DeltaPSU Product Notice

DIN Rail DRL-75W series Product Change Notice

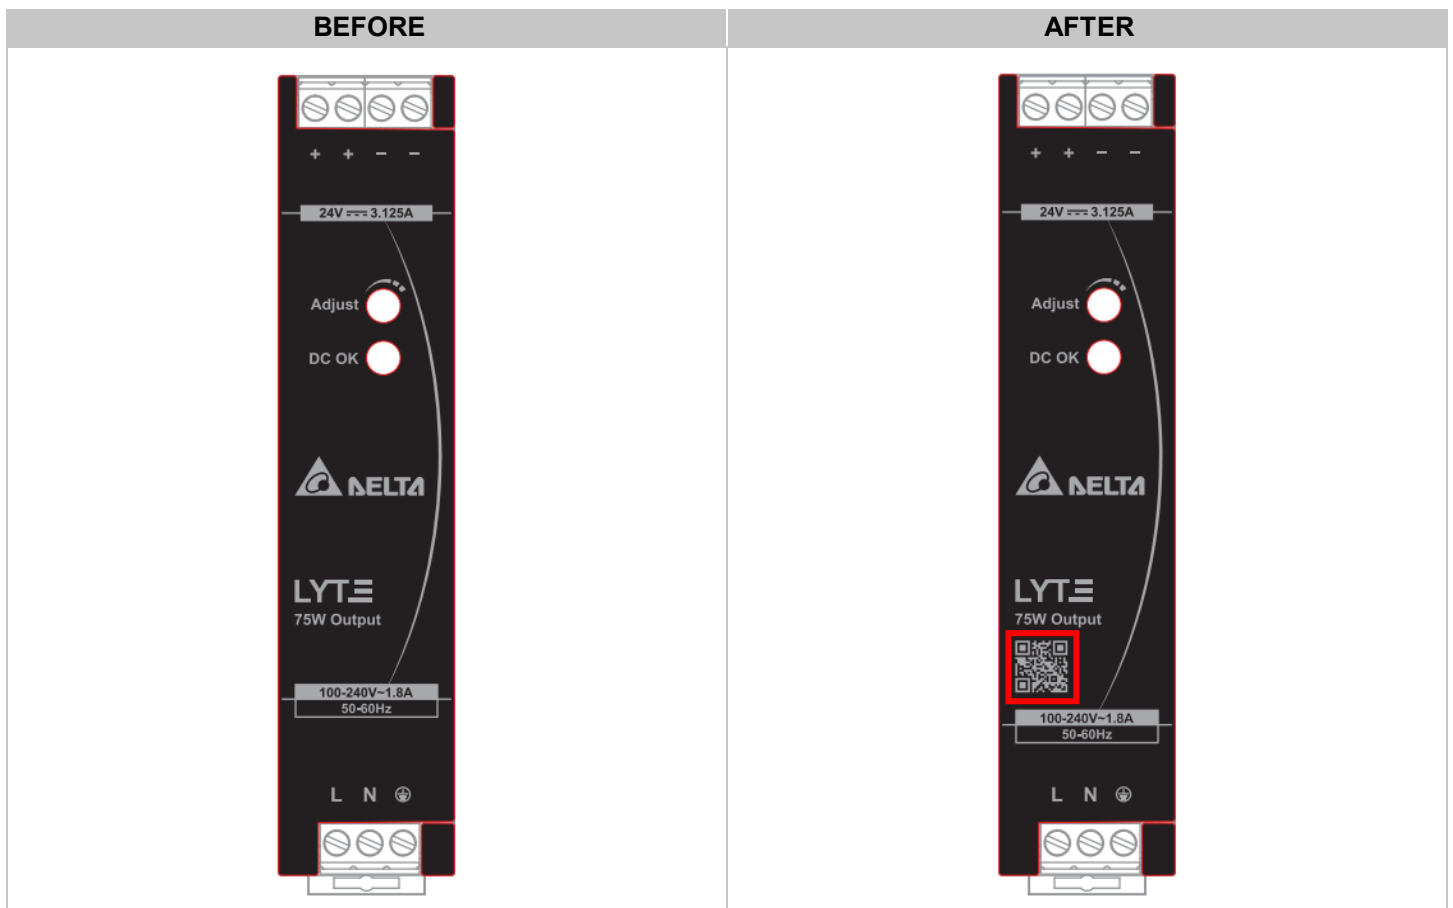
1. Front label change

- Implement “e-manual” downloading on front label. User can scan QR code and download instruction manual.
